DEVELOPMENT REVIEW COMMITTEE (DRC) COMMENT REPORT

PROJECT NAME: SPSA Retail

CASE NUMBER: R18023

REQUEST: Site Plan Level II Review: 12,482 Square Feet of Retail

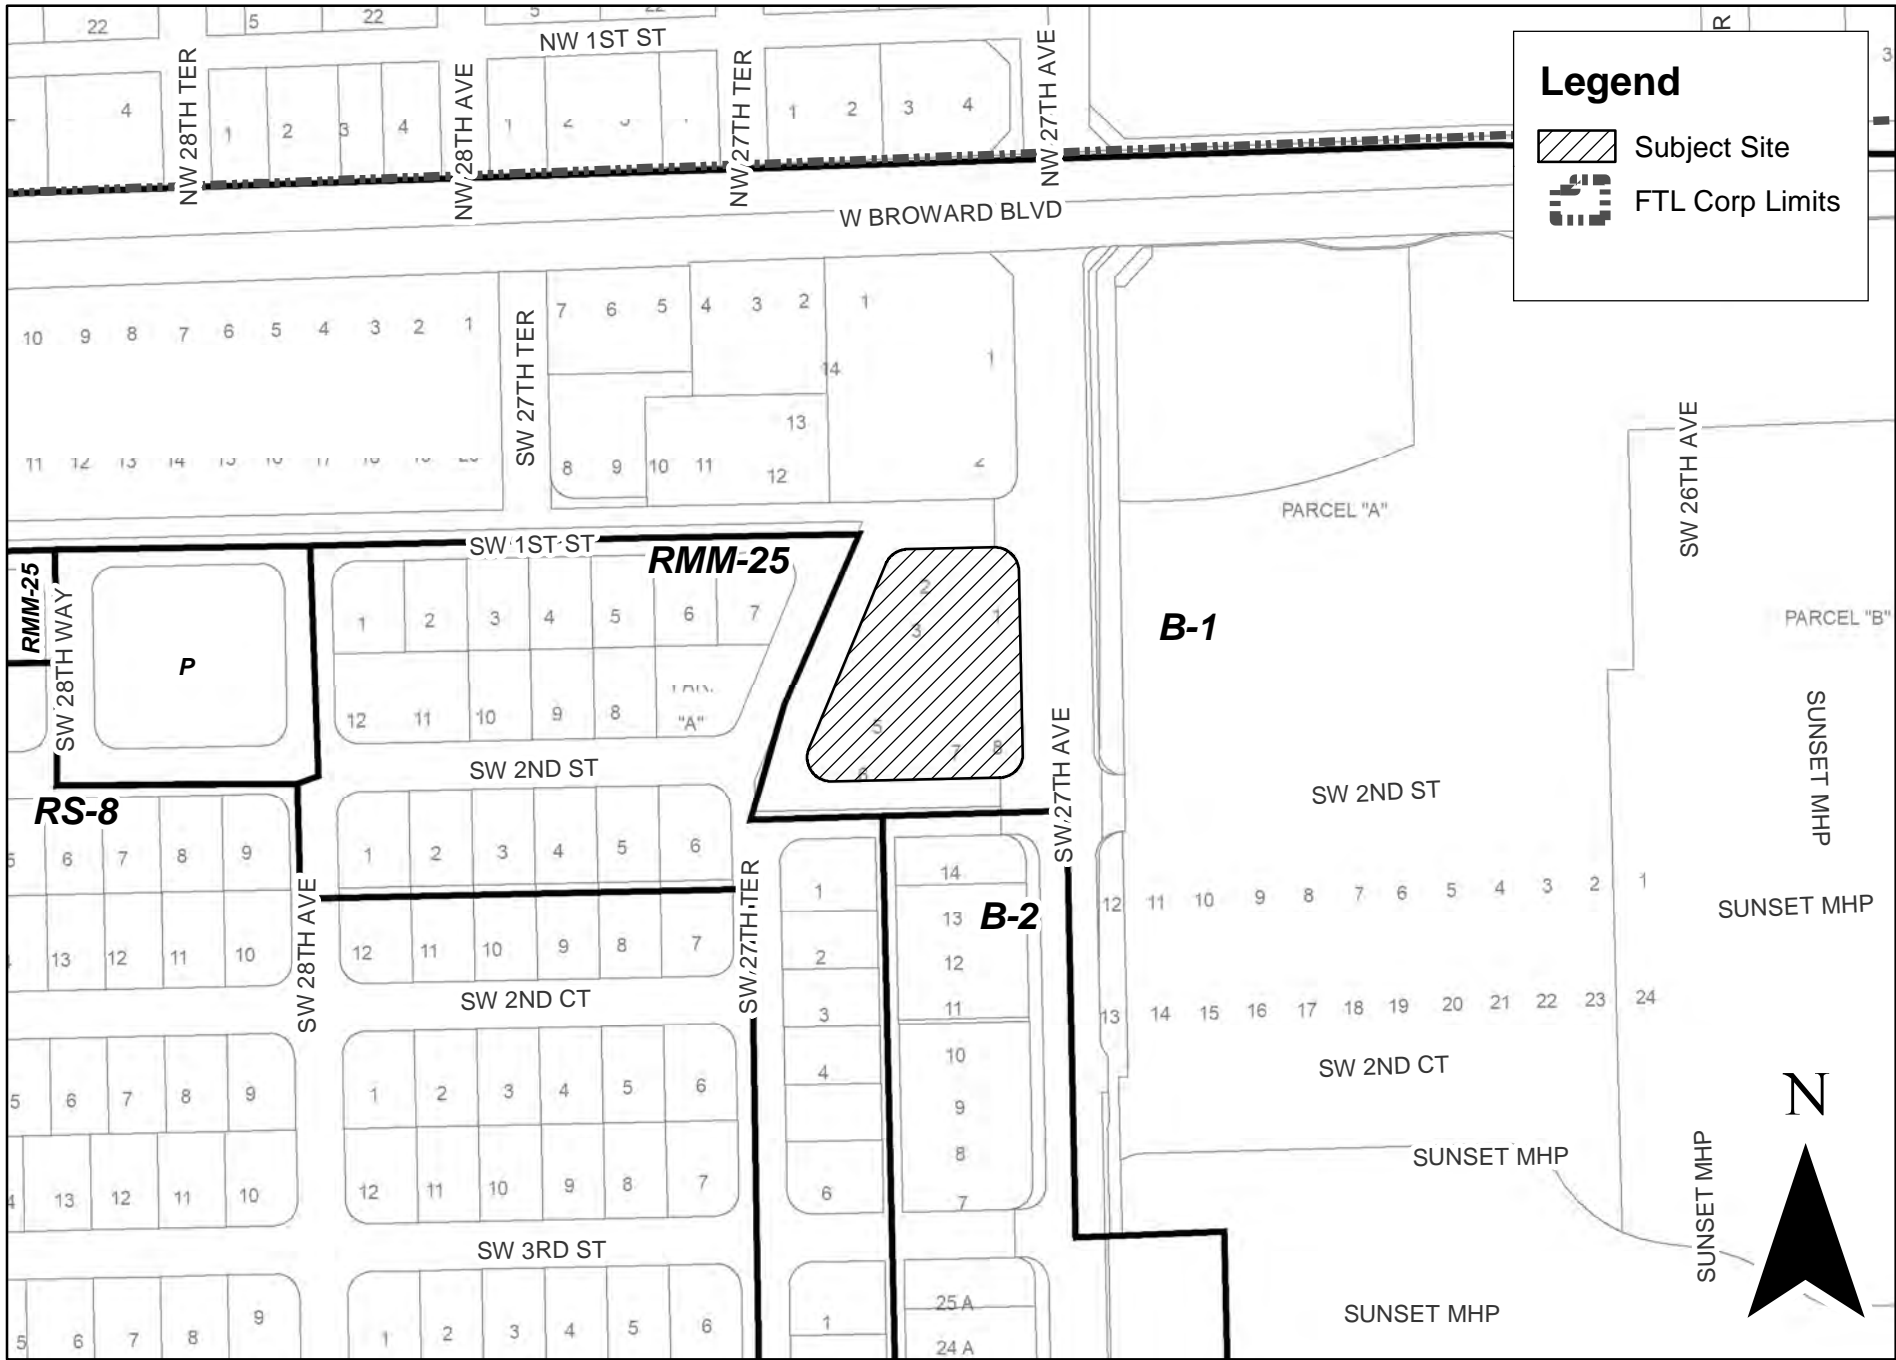
- 9) Provide canopy trees or clusters of palms in the two planters along SW 27th Ave (see also Landscape comments).
